DETERMINATION OF NON-SIGNIFICANCE

City of Bellevue
Development Services Department
Land Use Staff Report

Proposal Name: 305 Office Tower

Decisions Included: Process II, Combined Design Review decision and SEPA Determination

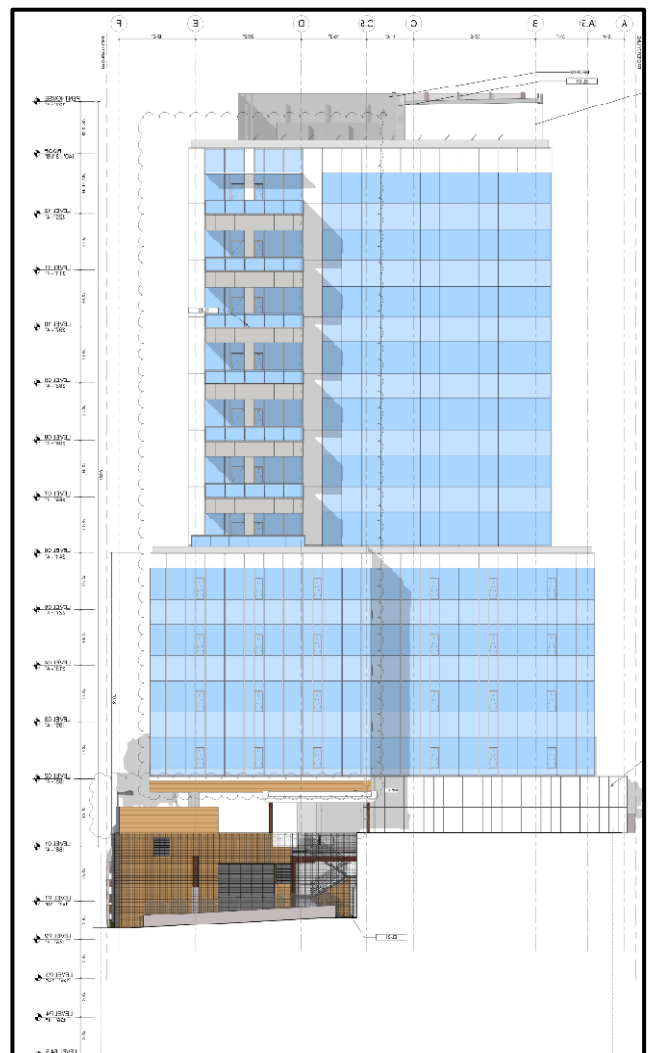
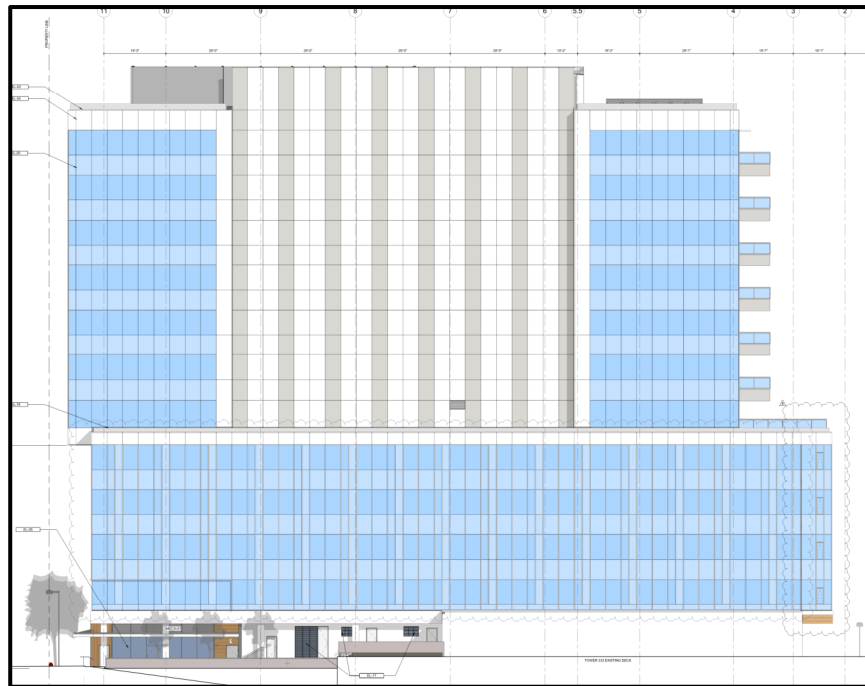
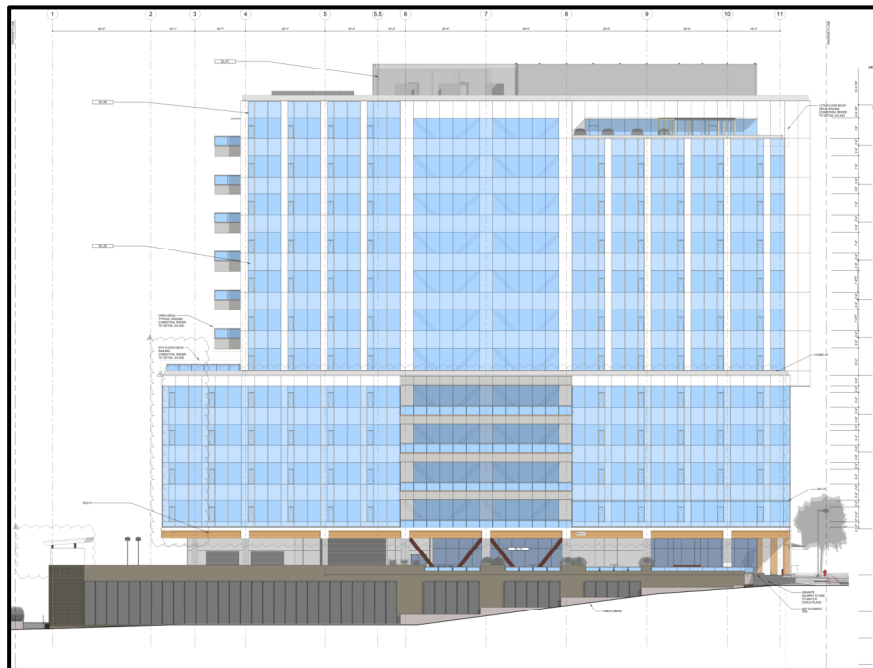
The building elevations show a portion of the northwest exterior wall with a distance to the property line of less than three feet along grid line 2, levels 1 through 5. Openings are not permitted in exterior walls located less than 3 feet from a property line and exterior walls less than five feet from the property line are required to have a 1-hour fire-resistance rating. The

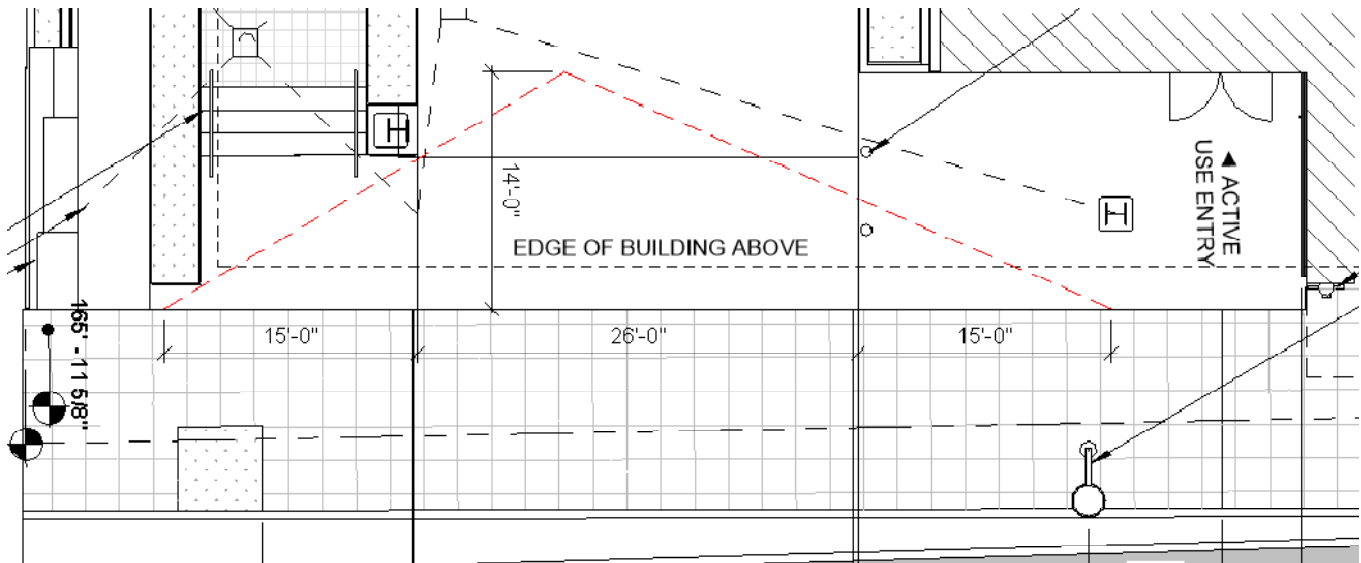
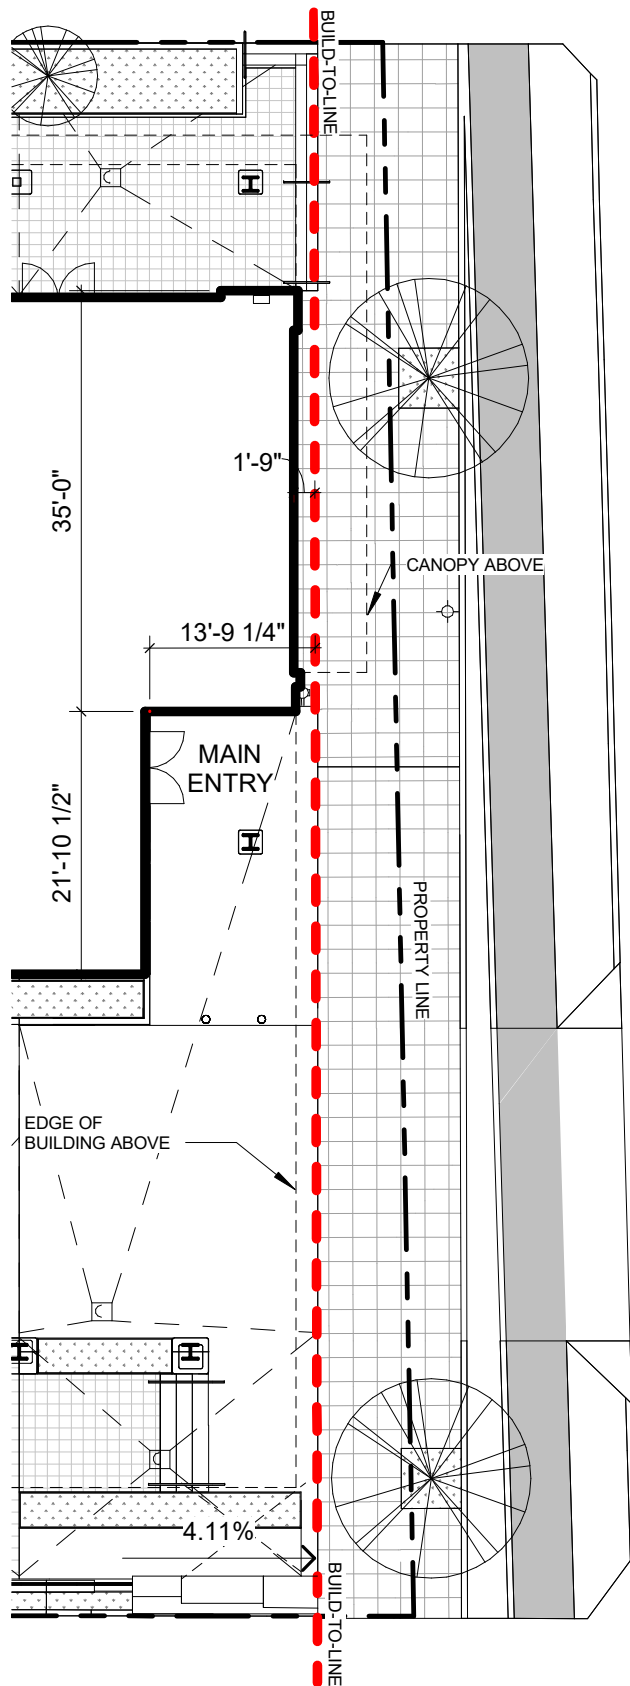
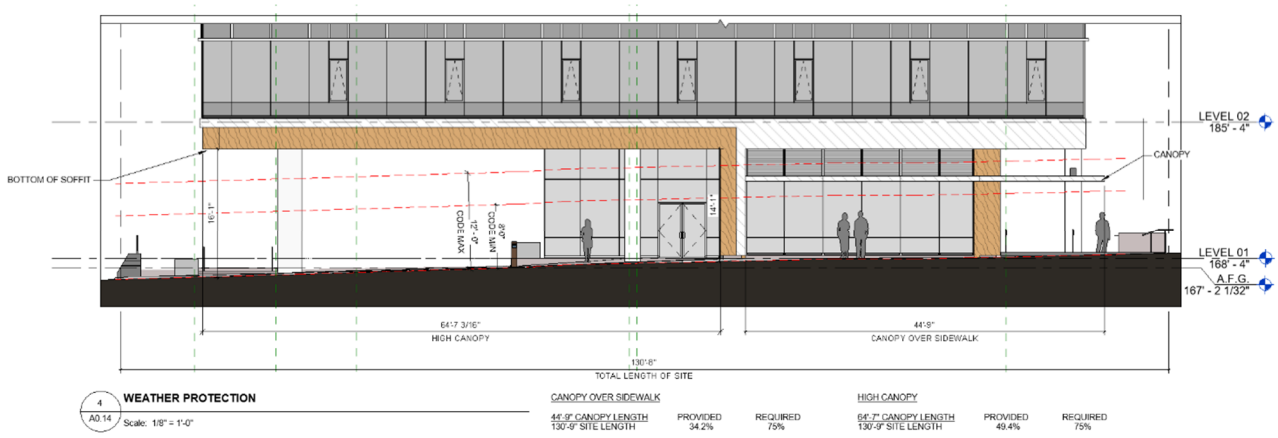
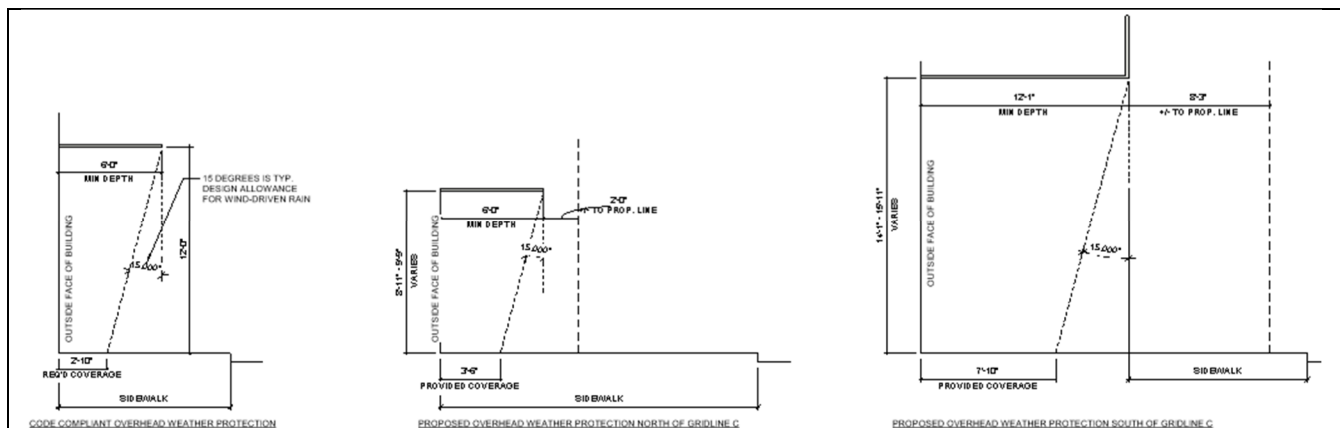
Pursuant to LUC 20.25A.030.D.1 and LUC 20.25A.060.A.1 a departure is requested to modulate the east façade of the building at the build-to (back of sidewalk) line. LUC 20.25A.060.A.1 allows exceptions to buildings being built to the “build-to” line where a plaza, building modulation or other ground-level open space is proposed. The proposed design has a modulated setback from the sidewalk to achieve the required sight distance triangle. See the exhibit at end of departure form.
See sheet A2.00 in the ADR drawing submittal.

The proposed modulation from the build-to line is the minimum needed to enhance the pedestrian realm, increase public safety and accommodate required sight triangle distances.

Not applicable. There are no specific departure criteria for build-to line deviations nor an applicable Development Agreement.

Trees not allowed due to clearance restrictions

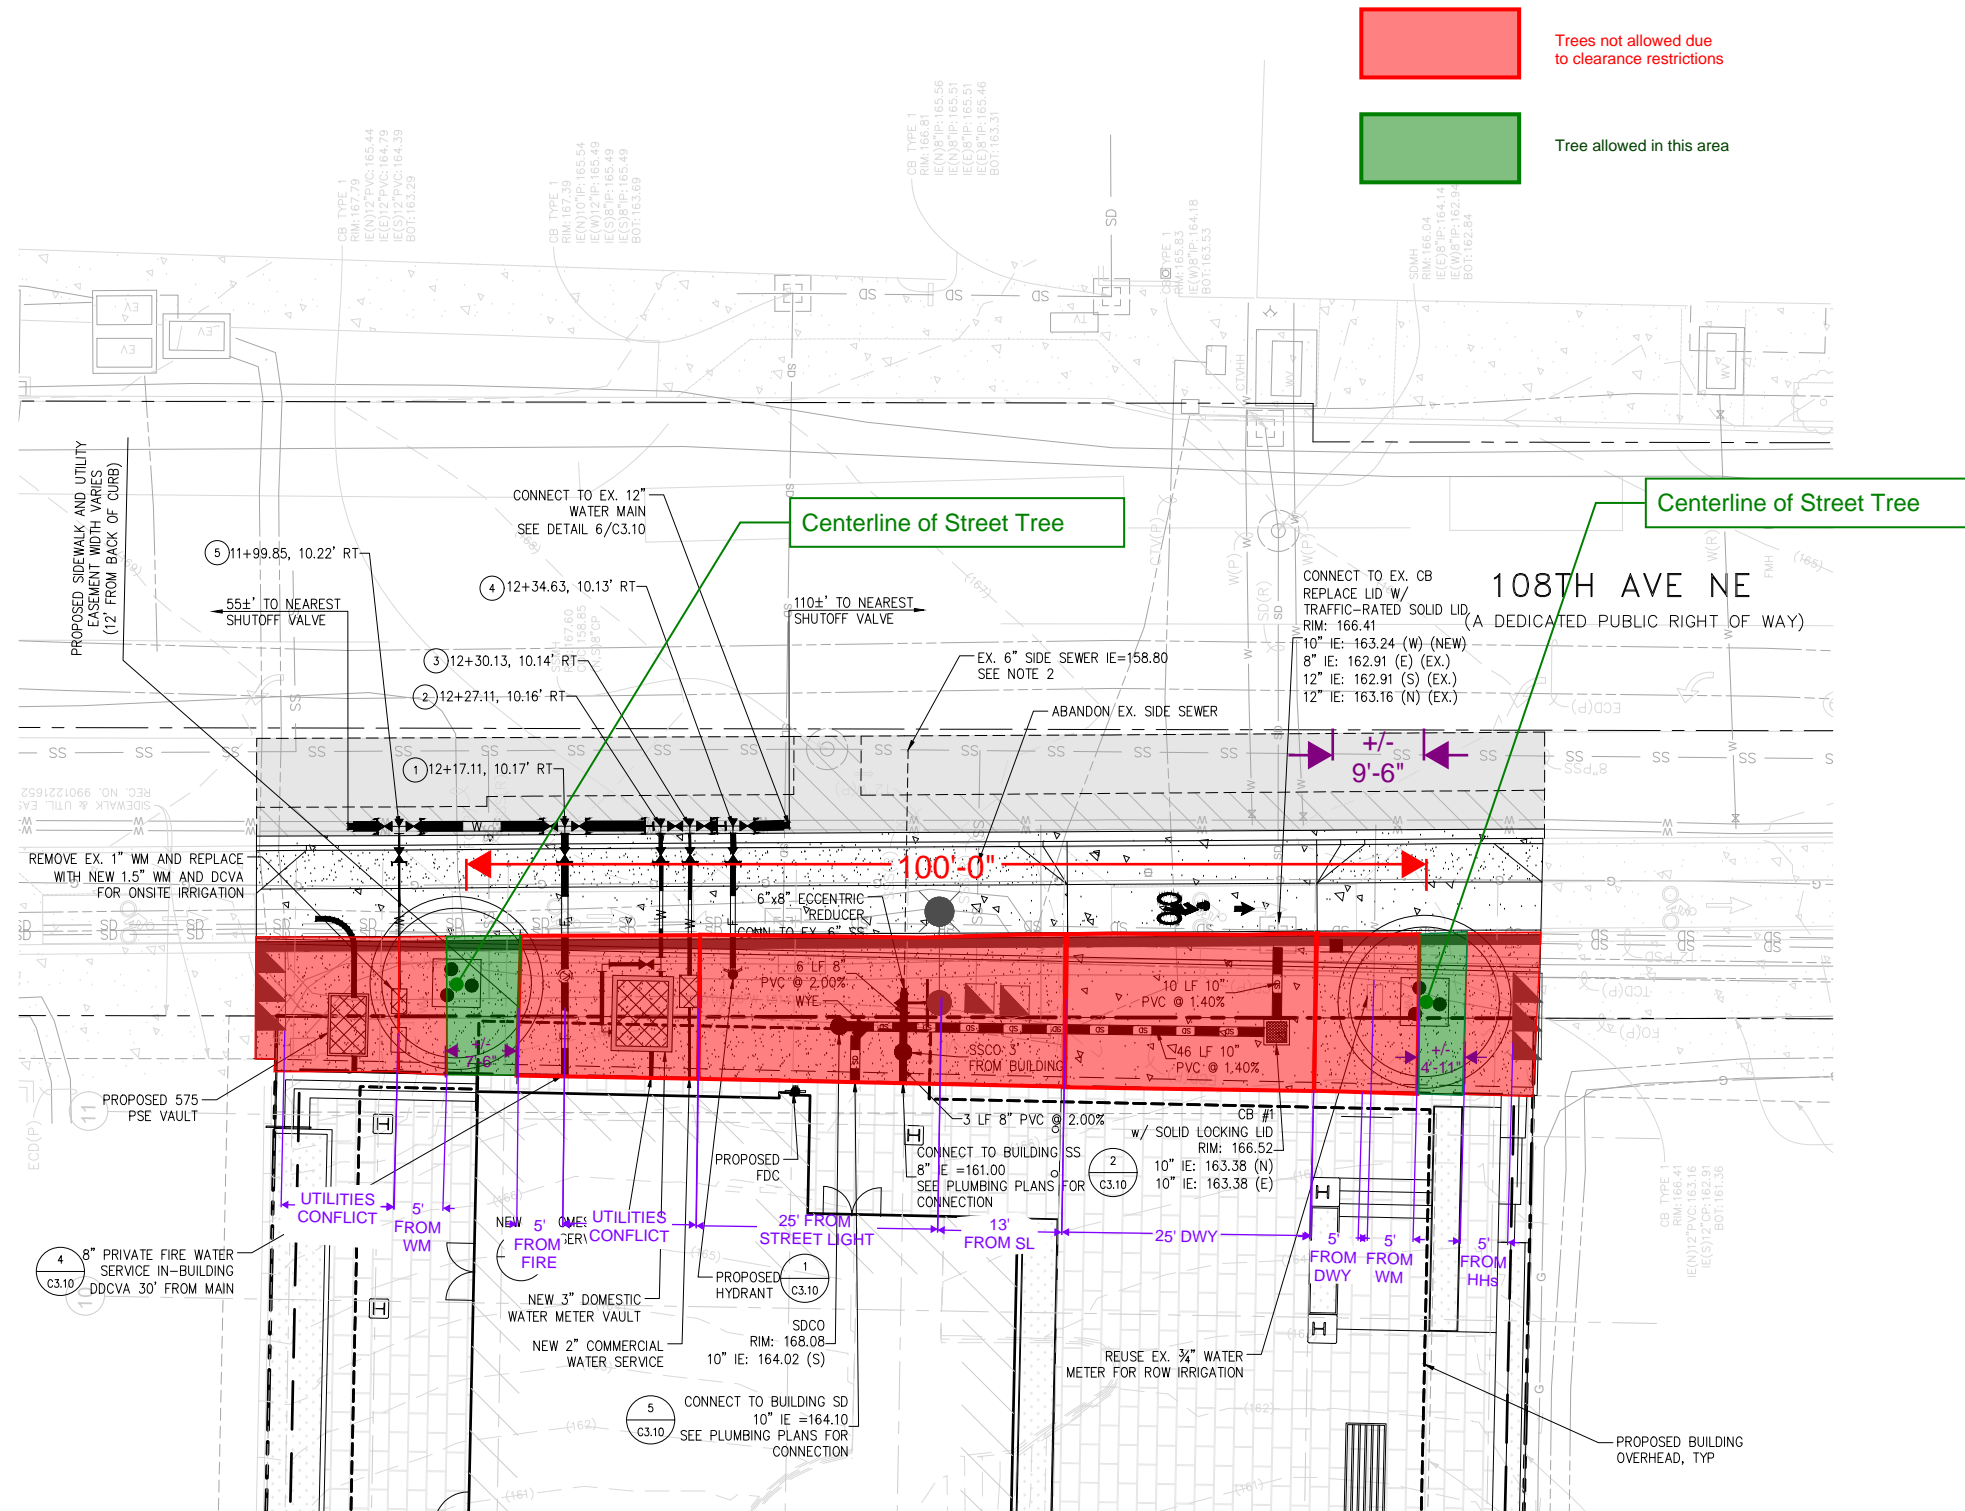
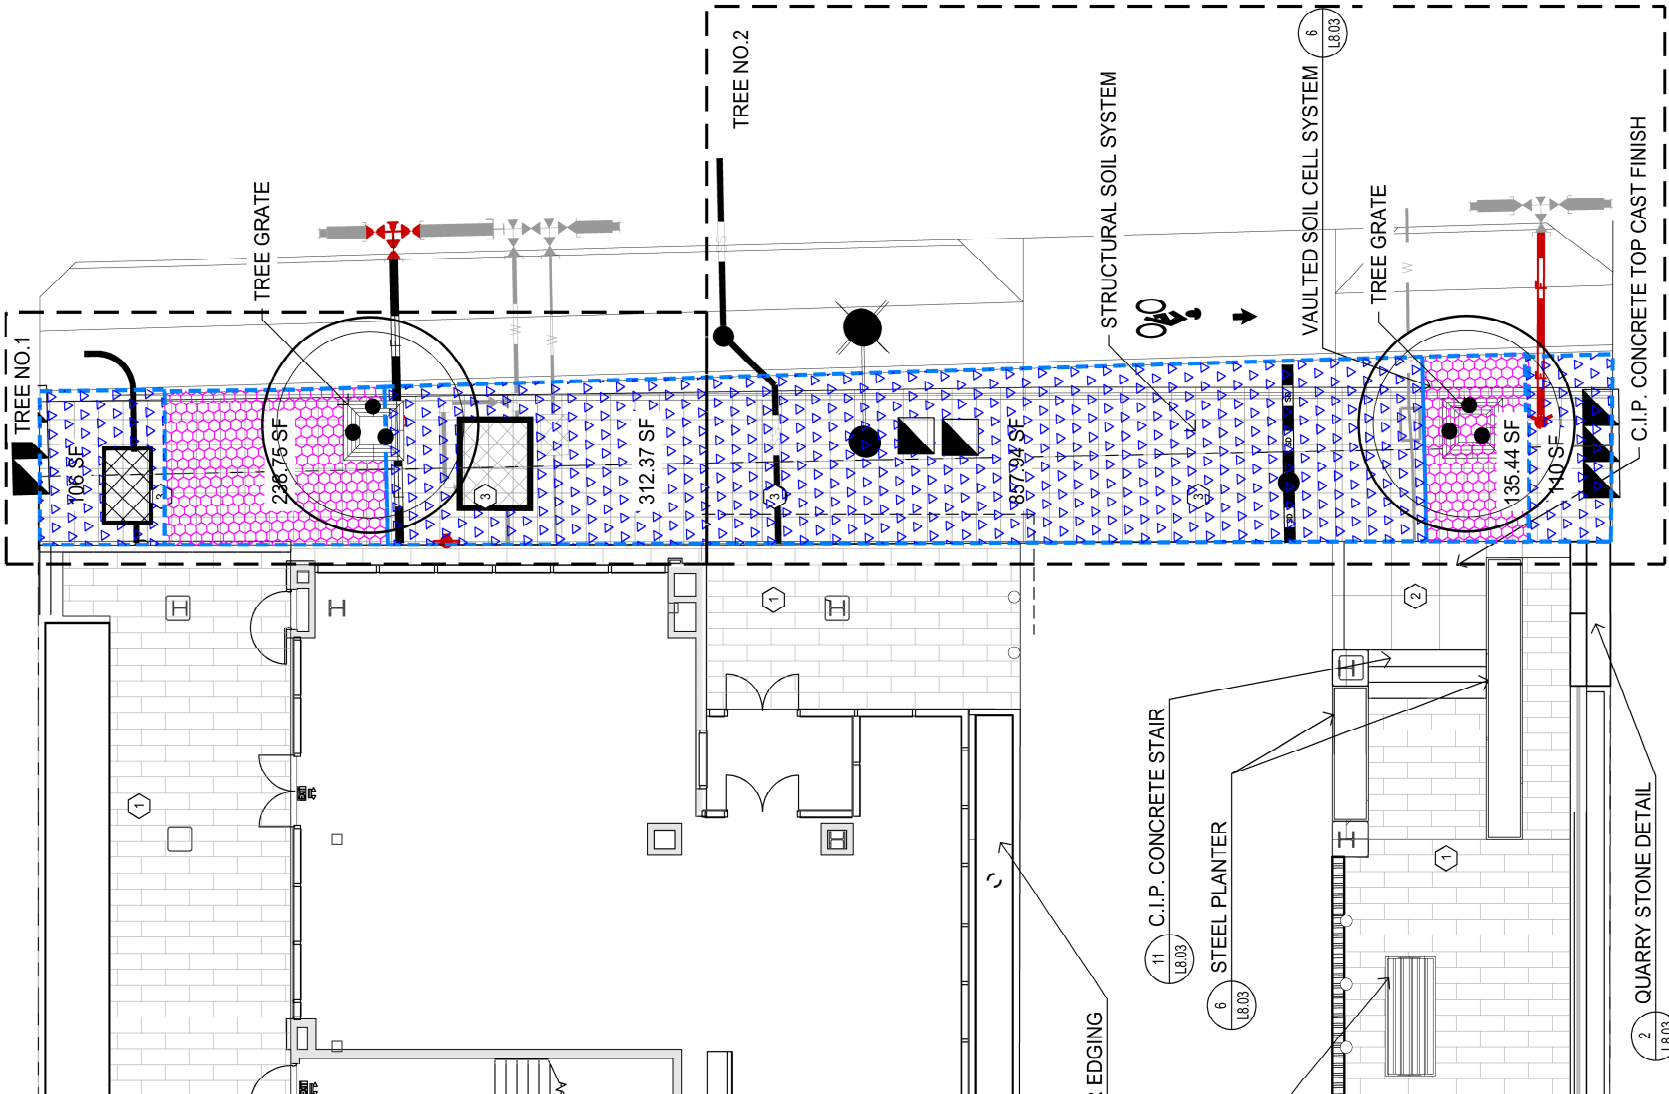
The applicant requests an administrative departure from LUC 20.25A.110.A which requires medium sized street trees to be spaced a maximum of 25 feet on center. The project proposes to space the medium sized trees 100 feet apart. Given the narrow street frontage (approx. 131') on a small development site, and the need to provide utility infrastructure and street lighting, this leaves only two small areas to provide the required street trees which results in a larger spacing request.

Response: Below grade utilities have been configured to allow the two proposed street trees to be as closely spaced as possible, while still meeting clearance distances for each utility, which also includes an above grade streetlight. The minimum modification reasonably necessary is a 100-foot spacing in lieu of the code required 25 foot spacing.

Response: The departure criteria for Landscape development, as listed above, have been met.
